Product Change Notification (PCN)

PCN Number: PCN_ConNPC2_20260430 Affected Series: WR-NPC2 Affected Part Number: see table "PART NUMBER, REVISION & DATASHEET" PCN Date: 2026-03-30 (YYYY-MM-DD) Effective Date: 2026-04-30 (YYYY-MM-DD)	Change Category: ☐ Equipment/Location ☒ General Data ☐ Material ☐ Process ☐ Product Design ☐ Shipping/Packaging ☐ Supplier ☐ Software
Contact: Product Management Phone: +49 (0) 7942 - 945 5001 Fax: +49 (0) 7942 - 945 5179 E-Mail: pcn.eican@we-online.com	Datasheet Change: ☒ Yes ☐ No Attachment: ☐ Yes ☒ No

As a datasheet information amendment, Würth Elektronik eiSos will correct product drawings. Peg position and dimension are precised on drawing and layout for each polarity.

Product drawing

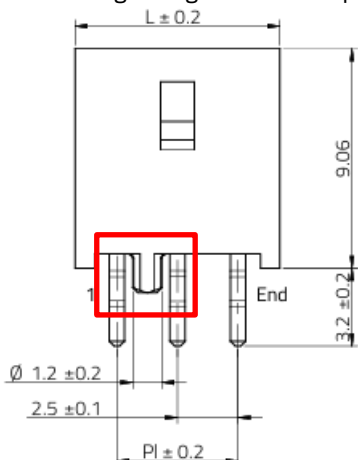
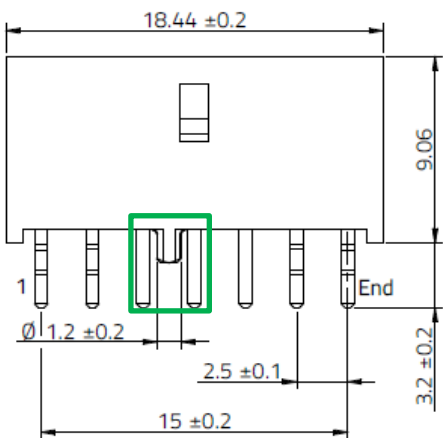
BEFORE CHANGE	AFTER CHANGE
The drawing was generic for all polarities. 	The drawing is precisely for polarity 5.

Product layout

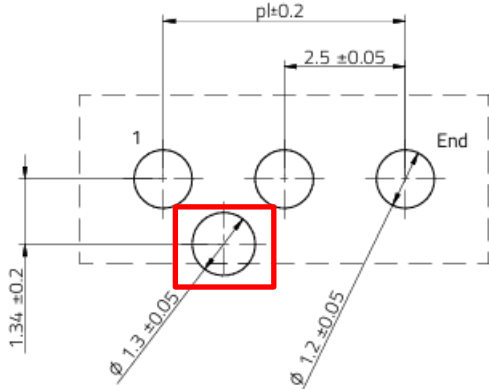
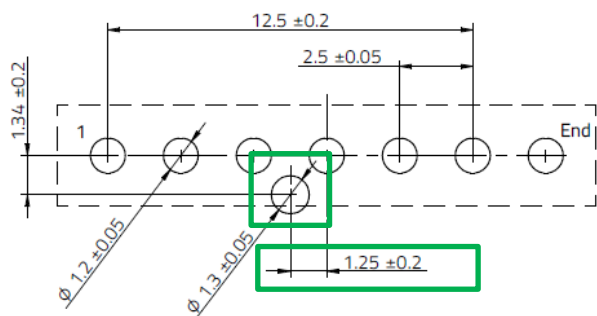
BEFORE CHANGE	AFTER CHANGE
The layout was generic for all polarities. 	The layout is precisely for polarity 5.

Product drawing

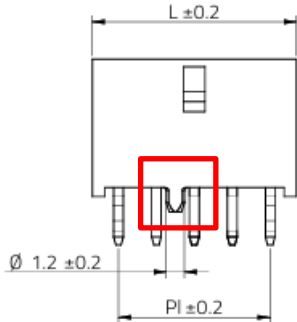
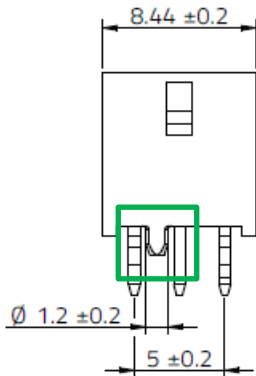
BEFORE CHANGE	AFTER CHANGE
The drawing was generic for all polarities.  Technical drawing showing a generic component layout. Dimensions include: overall length $L \pm 0.2$, overall height 9.06, pin pitch $Pl \pm 0.2$, pin diameter $\varnothing 1.2 \pm 0.2$, and pin spacing 2.5 ± 0.1. A red box highlights the pin area.	The drawing is precisely for polarity 7.  Technical drawing showing a specific component layout for polarity 7. Dimensions include: overall length 18.44 ± 0.2, overall height 9.06, pin pitch 15 ± 0.2, pin diameter $\varnothing 1.2 \pm 0.2$, and pin spacing 2.5 ± 0.1. A green box highlights the pin area.

Product layout

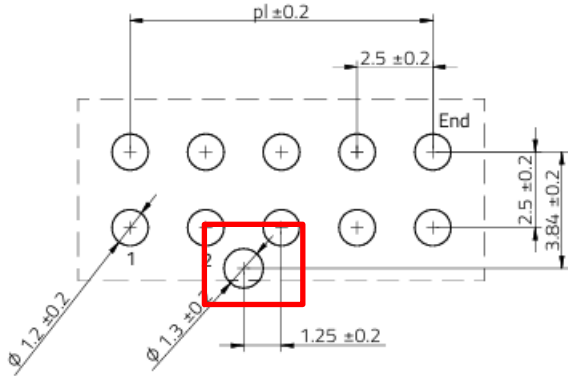
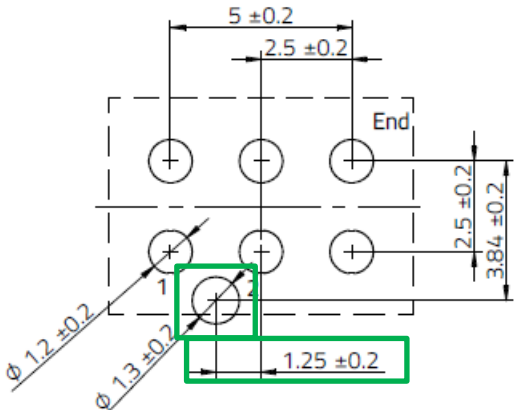
BEFORE CHANGE	AFTER CHANGE
The layout was generic for all polarities.  Technical drawing showing a generic component layout. Dimensions include: pin pitch $pl \pm 0.2$, pin diameter $\varnothing 1.3 \pm 0.05$, and pin spacing 2.5 ± 0.05. A red box highlights the pin area.	The layout is precisely for polarity 7.  Technical drawing showing a specific component layout for polarity 7. Dimensions include: pin pitch 12.5 ± 0.2, pin diameter $\varnothing 1.2 \pm 0.05$, pin spacing 2.5 ± 0.05, and pin diameter $\varnothing 1.3 \pm 0.05$. A green box highlights the pin area.

Product drawing

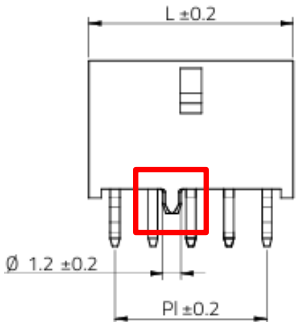
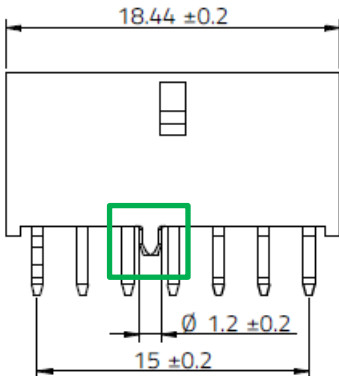
BEFORE CHANGE	AFTER CHANGE
The drawing was generic for all polarities.  Technical drawing of a component with dimensions: $L \pm 0.2$, $\varnothing 1.2 \pm 0.2$, and $Pl \pm 0.2$. A red box highlights the central pin area.	The drawing is precisely for polarity 6.  Technical drawing of the component for polarity 6 with dimensions: 8.44 ± 0.2, $\varnothing 1.2 \pm 0.2$, and 5 ± 0.2. A green box highlights the central pin area.

Product layout

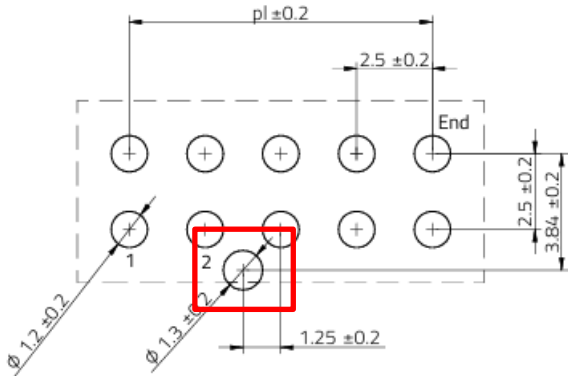
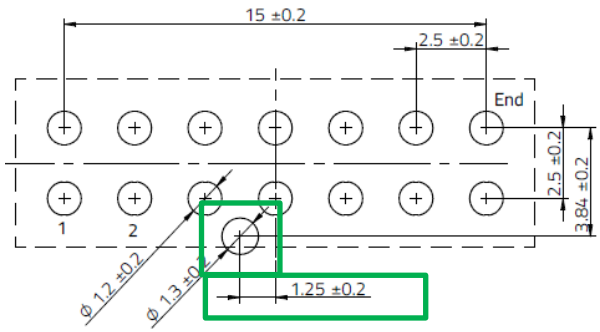
BEFORE CHANGE	AFTER CHANGE
The layout was generic for all polarities.  Technical drawing of the component layout with dimensions: $pl \pm 0.2$, 2.5 ± 0.2, $\varnothing 1.2 \pm 0.2$, $\varnothing 1.3 \pm 0.2$, 1.25 ± 0.2, 2.5 ± 0.2, 3.84 ± 0.2, and "End". A red box highlights the central pin area.	The layout is precisely for polarity 6.  Technical drawing of the component layout for polarity 6 with dimensions: 5 ± 0.2, 2.5 ± 0.2, $\varnothing 1.2 \pm 0.2$, $\varnothing 1.3 \pm 0.2$, 1.25 ± 0.2, 2.5 ± 0.2, 3.84 ± 0.2, and "End". A green box highlights the central pin area.
